CITY OF CHARLESTON

Planning Commission Agenda Package

February 19, 2020 2 George St, Charleston, SC
5:00PM - Regular Meeting

Agenda Item #: 8
 KERR TRACT RESIDENTIAL
 SUBDIVISION CONCEPT PLAN

118 lots. Request for subdivision concept plan approval.
Zoned Planned Unit Development (PUD) (Kerr Tract).

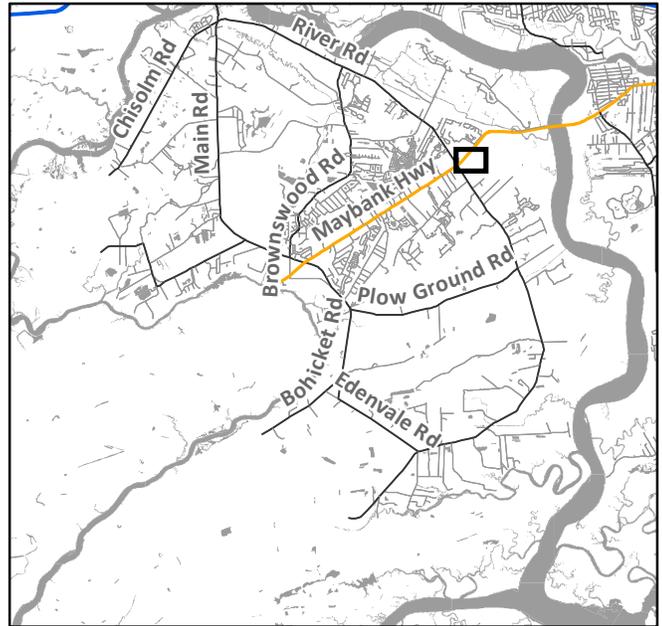
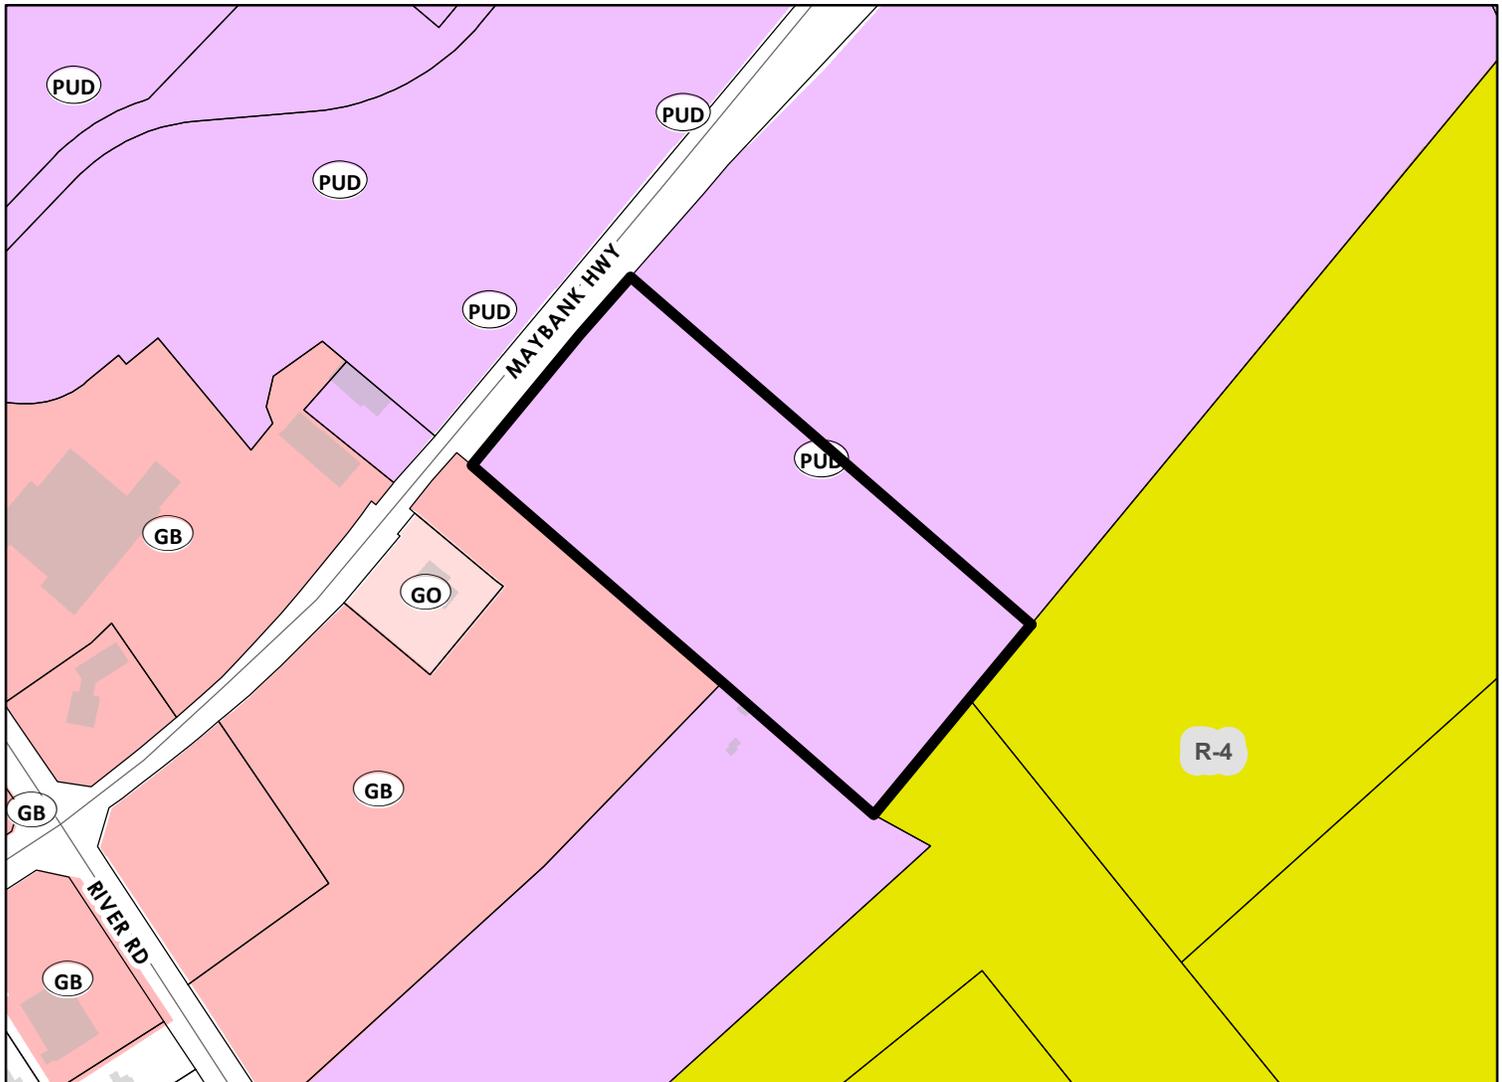
1. On site data table, provide information for lot area as it shows blank. What information should be included?
2. On site data table correct spelling of wetlands.
- ~~3.~~ Show tree protective areas as required.
4. Add names of existing streets within 150 feet of the property boundary with **ownership and maintenance**.
5. Per PUD document, VI-D, the location of the access point on Maybank Highway must be resolved with the Concept Plan submittal. Is this matter resolved?
6. Per PUD document, VI-G, "stand up curb is required where curb and gutter is used". At the present time we are not in favor of the plans for rolled curb throughout the entire development. If you want to modify some sections, provide your reasons for the proposed modification and it will be taken into consideration by the Zoning Administrator.

7. Are you providing enough on-street parking for visitors? Study plans.
8. Lots 1 -19 and 49-63: which direction are they facing? Will they be facing the alley?
9. Trees will require further study. Eric Schultz will coordinate.

Response: Lot information provided on Site Data Table

Response: Corrected Spelling

Response: Existing Street name and ownership provided. Maybank Highway (R/W varies) (SC Highway 700)

Response: Provided on-street parking for visitors. Will study the addition of more spaces.

Response: Lots 1-19 face away from the alley and have driveway access from the alley. The front of the buildings will face open space/green areas. Lots 49 – 63 face the Indigo vat or open space area.
